City of Phoenix
PLANNING AND DEVELOPMENT DEPARTMENT

**Staff Report Z-5-19-1
September 4, 2019**

Proposed Use: Single-Family Residential

Figure G. Illustration of the Casa de Montanas rezone (Z-113-06-1) and the subject site (Z-5-19-1) including the use of 47th Avenue as a shared accessway (depicted in red).

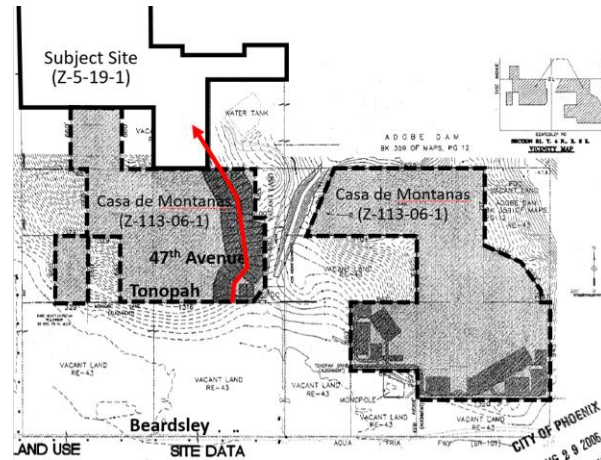
- A requirement that the applicant provide proof of legal access to the site. Stipulation No. 4.
- A requirement that roadway and drainage improvements pertaining to 47th Avenue be in general conformance with the plans presented to the Army Corps of Engineers. The Army Corps of Engineers have been involved in the project due to the proximity to the Adobe Dam Flood Control Facility. Stipulation No. 5

3. Roadway and drainage improvements pertaining to 47th Avenue shall conform to the design presented to the Army Corps of Engineers for application of the Section 408 permit, as approved by the Planning and Development Department.

Figure J. Proposed Off-Site Improvements

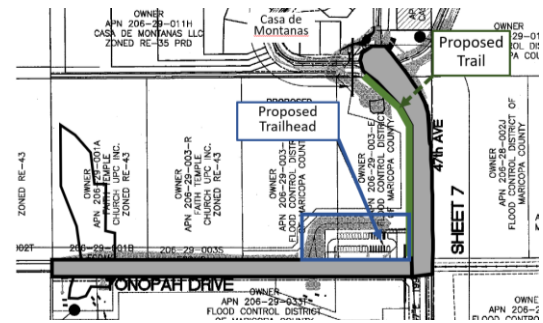
The proposed improvements depict a "10-foot detached sidewalk" at the above

location; however, staff recommends the pedestrian route comply with the specifications of a multi-use trail easement and trail.

Figure K. Typical Elevation (Uphill Prototype Elevation)

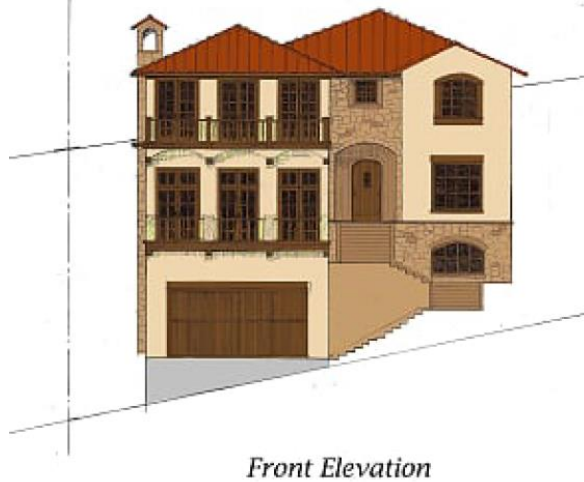
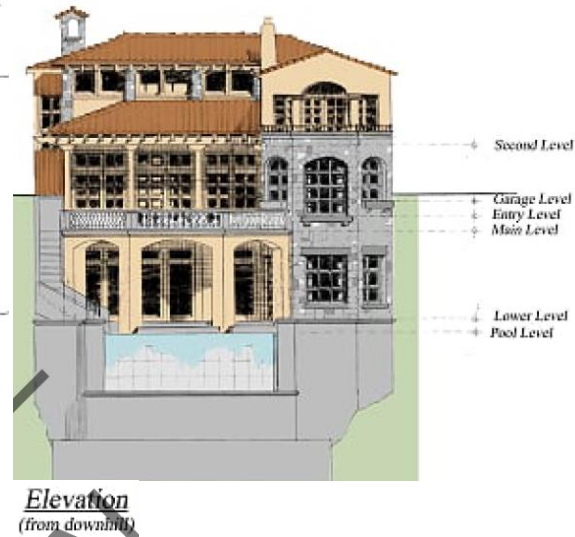
The height requirement of Section 710 is a maximum of two stories, not to exceed 30 feet above natural grade. It appears several of the conceptual elevations may not currently comply with this requirement.
